Model: ARDF (DF3030)	Date: 23-Oct-08	No.: RD366001a
-----------------------------	-----------------	----------------

Subject: Firmware Release Note: ARDF		Prepared by: T. Nihei	
From: 1st Overseas Tech Support Sec., 1st PQM Dept.			
Classification:	<input type="checkbox"/> Troubleshooting	<input type="checkbox"/> Part information	<input type="checkbox"/> Action required
	<input type="checkbox"/> Mechanical	<input type="checkbox"/> Electrical	<input type="checkbox"/> Service manual revision
	<input type="checkbox"/> Paper path	<input type="checkbox"/> Transmit/receive	<input type="checkbox"/> Retrofit information
	<input checked="" type="checkbox"/> Other ()

Model: DF 3030	Date: 19-Aug-09	No.: RD366002b
----------------	-----------------	----------------

Subject: Paper feed improvement		Prepared by: S. Tomoe	
From: 1st Tech. Support Sec. Service Support Dept.			
Classification:	<input type="checkbox"/> Troubleshooting <input type="checkbox"/> Mechanical <input type="checkbox"/> Paper path <input type="checkbox"/> Product Safety	<input checked="" type="checkbox"/> Part information <input type="checkbox"/> Electrical <input type="checkbox"/> Transmit/receive <input type="checkbox"/

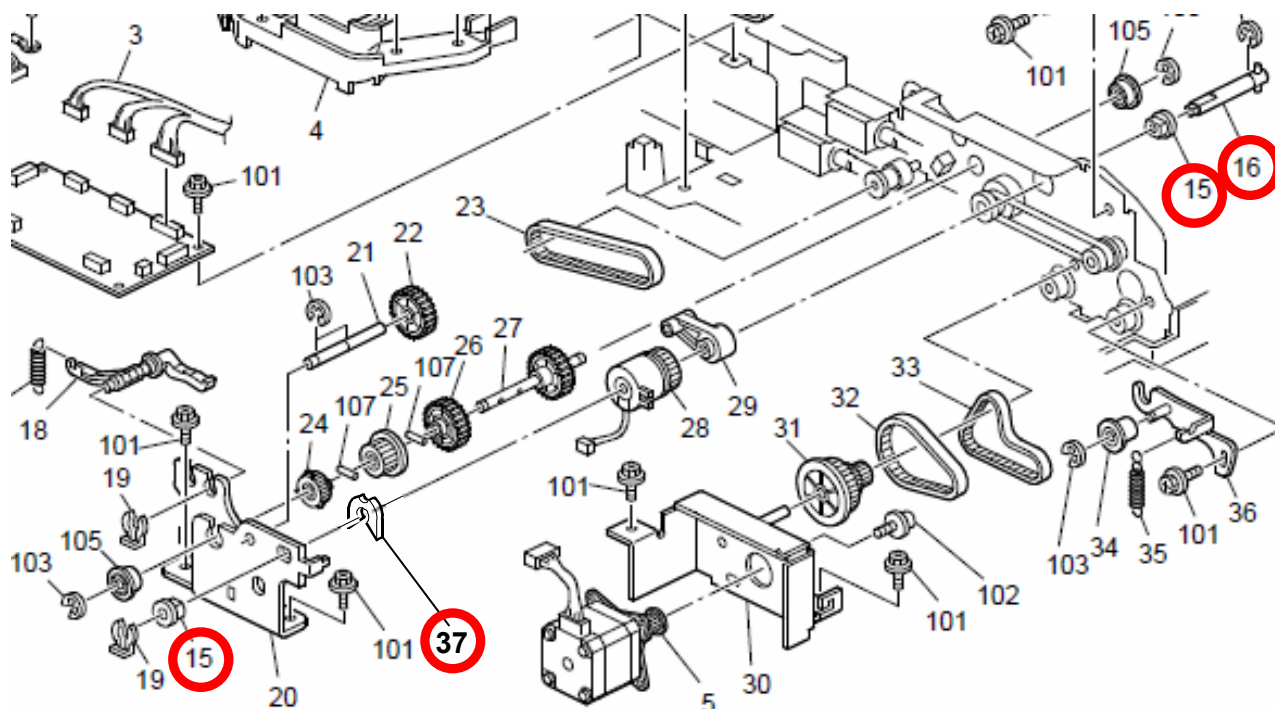
Old part number	New part number	Description	Q'ty	Int	Page	Index	Note
AA082104	53041639	Bushing - 8MM	2-2	X/X	13	15	X/O as a Set
B7894215	D3664215	Shaft: Magnetic Clutch	1-1	X/X	13	16	
	08050088	Retaining Ring - M6	0-1	X/X	13	37

Change: The shapes of the bushing and shaft were changed, and a retaining ring was added.

Reason: To further improve feeding of originals.

Important: If you replace the old shaft in the field, make sure to install the new bushing and retaining ring together as a set.

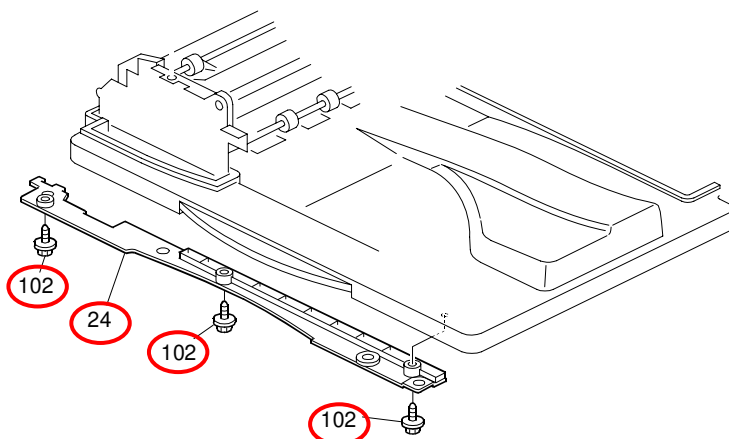
Old part number	New part number	Description	Q'ty	Int	Page	Index	Note
	D3661947	COVER:BASE	0-1		3	24	
	04503008N	TAPPING SCREW - M3X8			3	102

Change: The parts in the table were added.

Reason: To cover the ribs on the base.

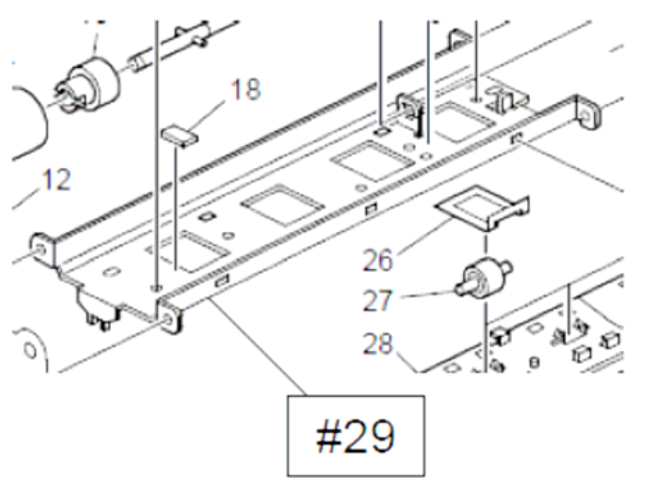
Incorrect part number	Correct part number	Description	Q'ty	Int	Page	Index	Note
	B7891161	STAY:SEPARATION	0 - 1		7	#29

Change / Reason: A new index was added to the illustration.

See the following diagram for the corrected illustration.

7.Frame Section (D366)

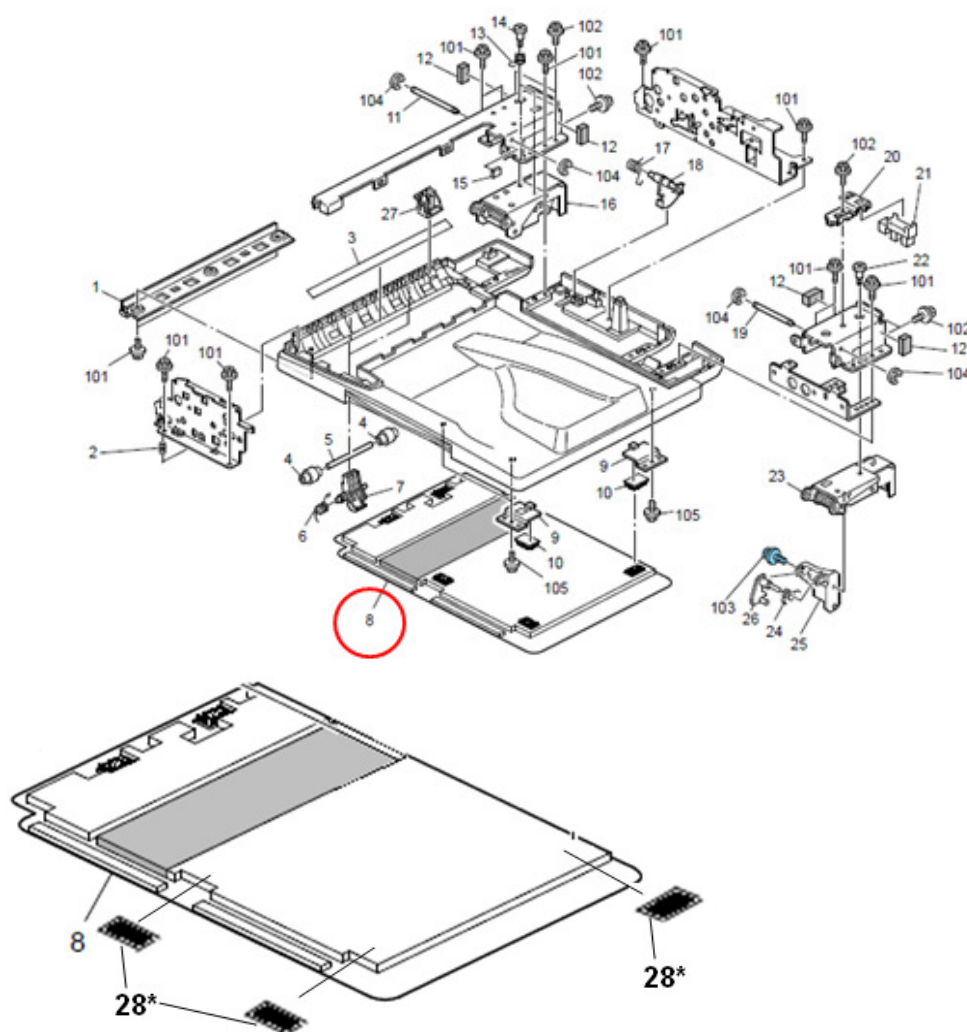
Change/Reason: The following part in the parts catalog was incorrect.

New part number	Description	Q'ty	Int	Page	Index	Note
B3514322	TAPE - PLATEN SHEET	3		15	28*

Note: Index 8 (PRESSURE PLATE ASS'Y) does not include index 28* (TAPE - PLATEN SHEET).
